Subject: Revision 3 to Ice Condenser Utility Group Topical Report No. ICUG-001:
*Application of the Active Ice Mass Management Concept to the Ice Condenser
Ice Mass Technical Specification*

Topical Report ICUG-001, Revision 3

SUBJECT: SAFETY EVALUATION FOR ICE CONDENSER UTILITY GROUP TOPICAL
REPORT NO. ICUG-001, REVISION 2 RE: APPLICATION OF THE ACTIVE ICE
MASS MANAGEMENT CONCEPT TO THE ICE CONDENSER ICE MASS
TECHNICAL SPECIFICATION (TAC NO. MB3379)

Figure O-1. Ice Mass Surveillance Strategy

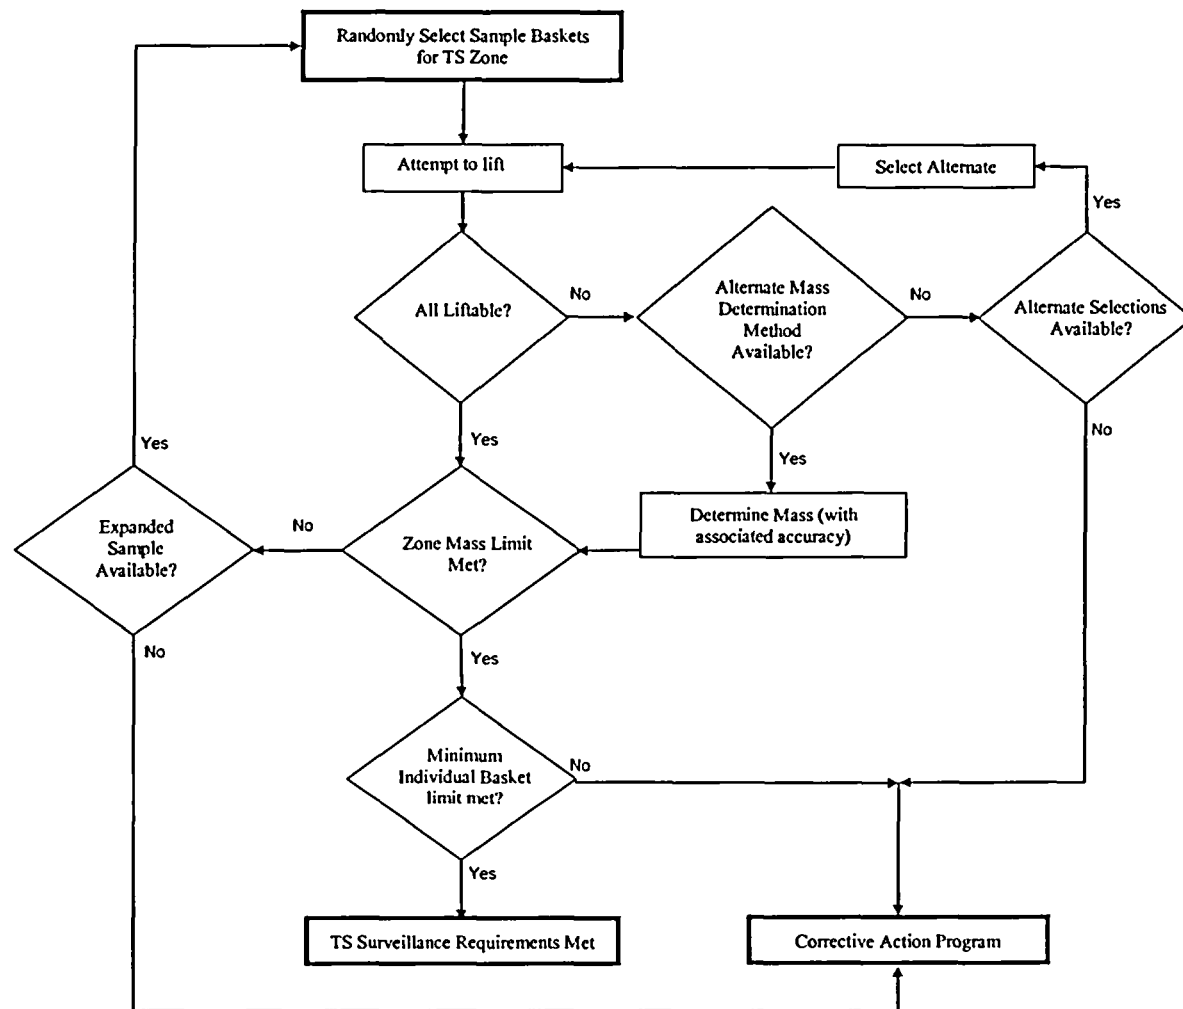
10. Page O-4, **Figure O-1**: Revised term in flow diagram "Blowdown Limit" to "Minimum Individual Basket Limit" per reference 22.
11. Page O-5, **Table O-1**: Revised fourth bullet to: "A surveillance for minimum total ice mass in the bed assures the initial conditions of the DBA analyses". Deleted fifth bullet. Revised sixth bullet to: "A surveillance for minimum ice mass in each individual basket prevents localized degradation to avoid any challenge to the DBA containment pressure response". Revised eighth bullet to: "Proper azimuthal distribution of ice in the ice bed is no longer assessed by a separate surveillance requirement; it is implemented through established industry-wide maintenance practices that manage each ice basket above the required safety analysis mean and confirmed through as-found random sampling techniques". Revised ninth bullet to: "All ice baskets in the parent population are subject to random statistical sampling, as opposed to only two-thirds of the population subject to representative sampling." Changes per references 22 and 27.

Figure 1-2. Row-Group Sublimation Rates

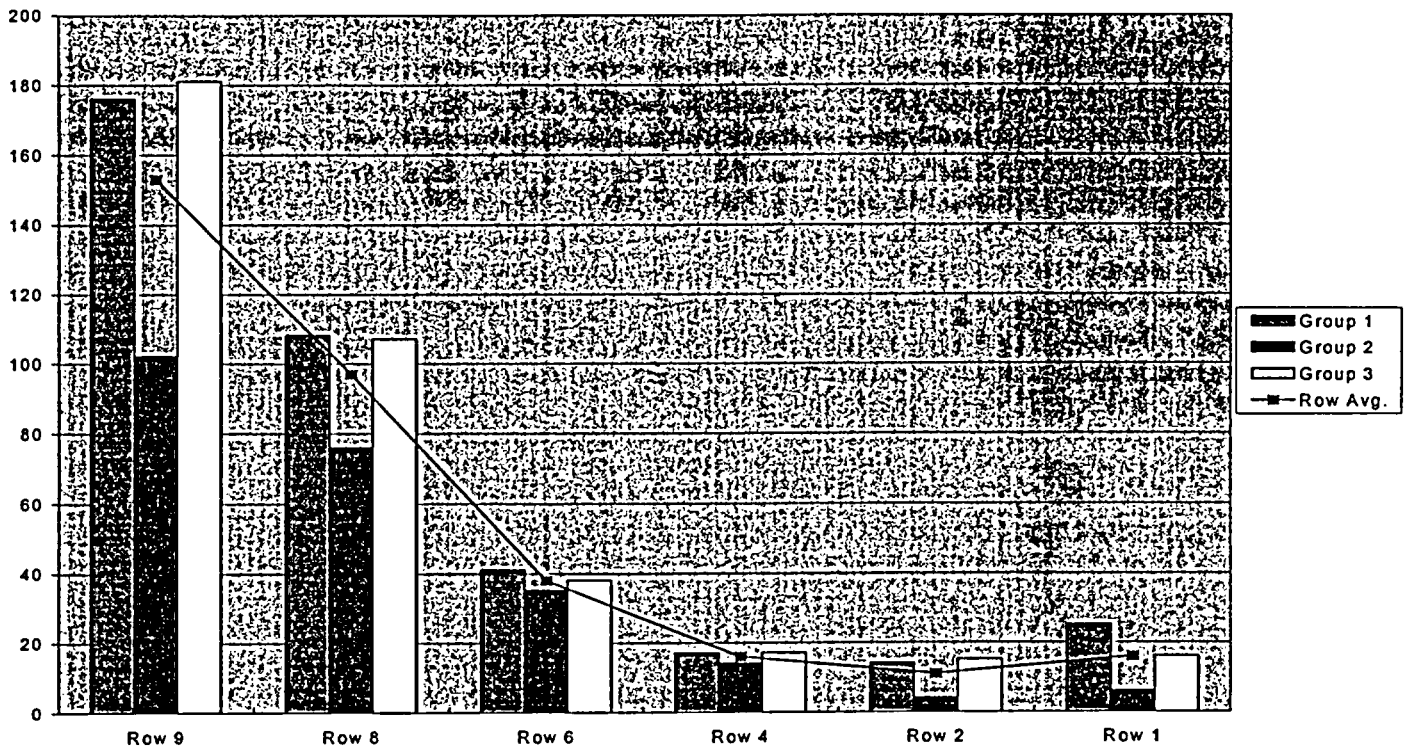
With respect to alternate basket sampling, the NRC staff's review of ICUG-001, Table 1-1, Figure 1-2, Table 1-2, and Table A-1 found, as stated by the ICUG report, that the greatest degree of sublimation occurs in radial zone A (inner rows 9, 8, and 7). The NRC staff noted, in RAI no. 3 that significant differences in sublimation rates appeared among Rows 9, 8, and 7, and that more frozen ice baskets exist in Row 9 than in Rows 7 or 8. The assumptions for the criteria for the selection of alternate baskets within a zone are that they are likely to have similar masses and to have similar probabilities of being selected. In RAI No. 3, the NRC staff asked the ICUG to explain how these two apparent deviations from the alternate selection criteria assumptions would affect the accuracy of the mass determination.

In reviewing Table 1-1 and Figure 1-2 of the topical report, the staff noted that significant differences in sublimation rates appeared among Rows 7, 8, 9 and that more frozen ice baskets exist in Row 9 than in Rows 7 or 8. In RAI No. 3, the NRC staff asked ICUG to explain how the differences and the frozen baskets would affect the accuracy of the weight measurement by using the radial zone concept.

Figure 1

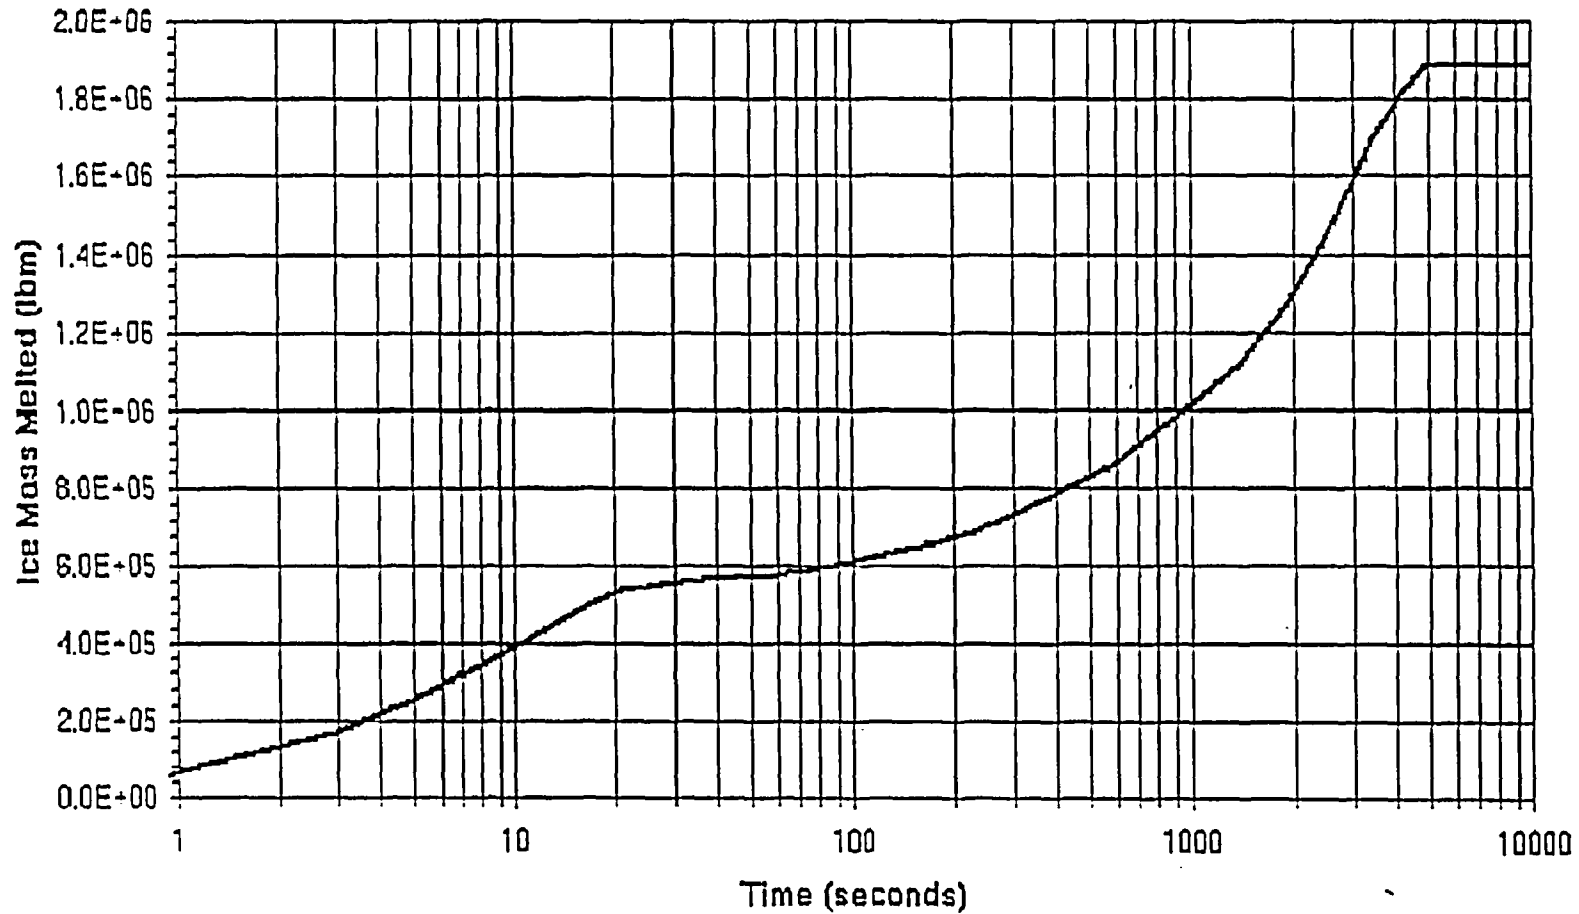
From Figure 1, the end of the blowdown phase (i.e., from $t=0$ sec to approximately $t=30$ sec) shows a total ice melt of about [560,000] lb, which is equivalent to about [288] lb of ice per basket. This represents the minimum amount of ice per basket that will withstand the blowdown phase of the DBA, essentially preventing the "burn-through" scenario described in the topical report. Similarly, for the other ice condenser plants:

Figure 1 - Containment Pressure Response Comparison
Postulated Ice Mass Deficiency in Radial Zone A, Sector 1

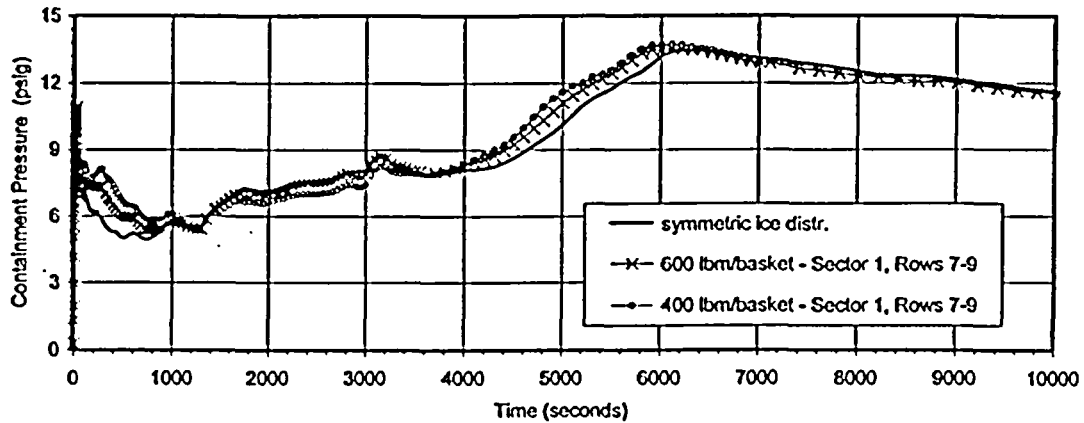
In Figure 1, the containment pressure for the first two sensitivity cases and the baseline case are presented. The containment pressure trends for the cases are very similar until after 3000 seconds, when the containment spray source is switched from the ambient water of the Refueling Water Storage Tank to the warmer sump water. Due to the lower ice mass remaining relative to the baseline case, the containment pressure increase in the sensitivity case is slightly faster. The peak containment pressure in the first sensitivity case is 13.50 psig, reached at 6100 seconds. This is within 0.1 psi of the peak pressure reached in the baseline case (13.44 psig, reached at 6300 seconds). In the second sensitivity case, containment pressure reaches a peak value of 13.73 psig at 6000 seconds.

Figure 5 - Ice Mass Melt Comparison
Postulated Ice Mass Deficiency in Radial Zone A, Sector 1

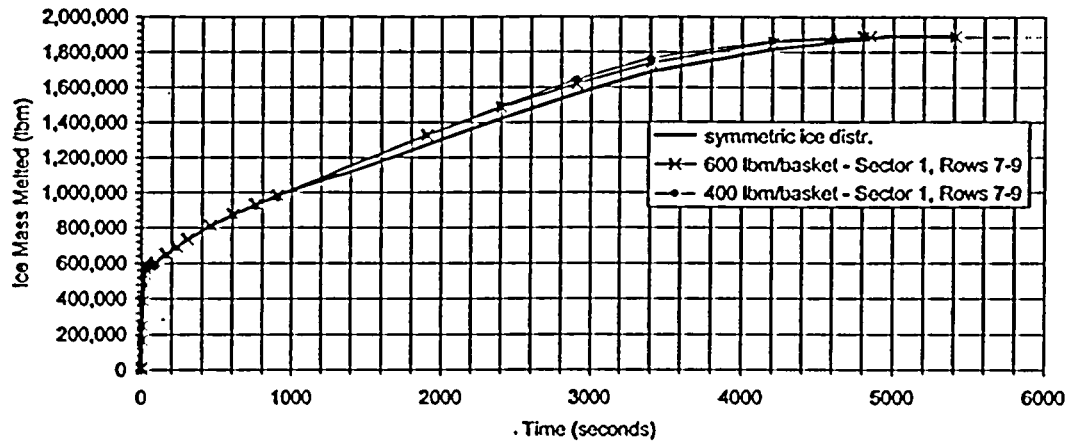
In Figure 5, the total ice melt is plotted for the cases. The ice melt in the sensitivity cases is greater by as much as 60,000 lb to 90,000 lb through the first hour of the transient. This is due to the initial ice mass maldistribution modeled above the break in the sensitivity cases, causing greater steam penetration into the ice bed earlier in the transient. This allows some areas of the ice bed to be exposed to steam earlier due to the cross-flow present within the ice bed.
